Professional Audio Products Technical Bulletin 10-2008-004R

SUBJECT: PARTS REGISTRATION—XLR MICROPHONE CONNECTOR

Figure 1

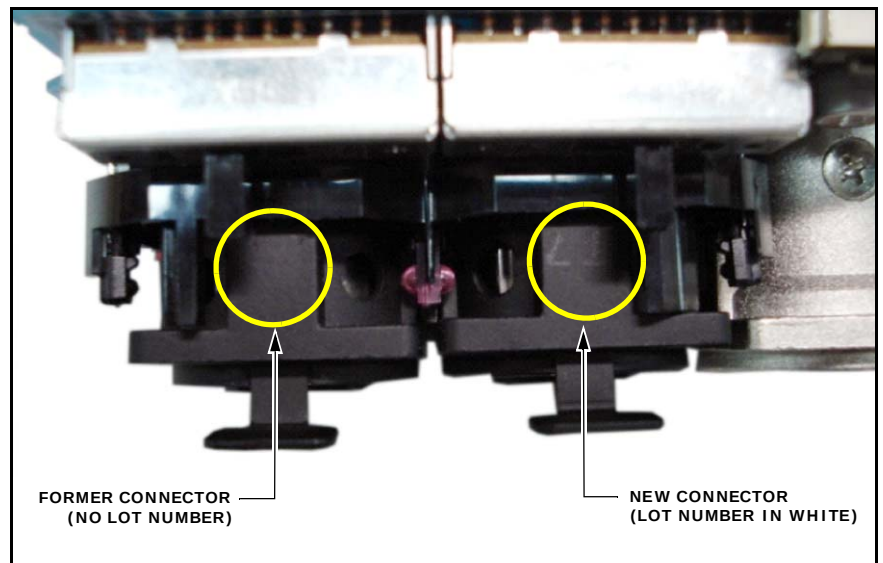
To distinguish between former and new connectors, inspect the lot number printed on the connector. (See Figure 1.)

Connector	Lot No.
1-573-281-11	No lot no. printed
1-573-594-11	No lot no. printed
1-573-594-21 or -22	Lot no. printed in black
1-573-594-12 or -23	Lot no. printed in white

When replacing the XLR microphone connector, use the following new connector:

Former Connector		New Connector
1-573-281-11	→	1-573-594-12
1-573-594-11		1-573-594-12
1-573-594-21 or -22		1-573-594-23

The new microphone connector uses beryllium copper for the contactor points, which is approximately ten times more durable than the copper alloy used in former connectors.
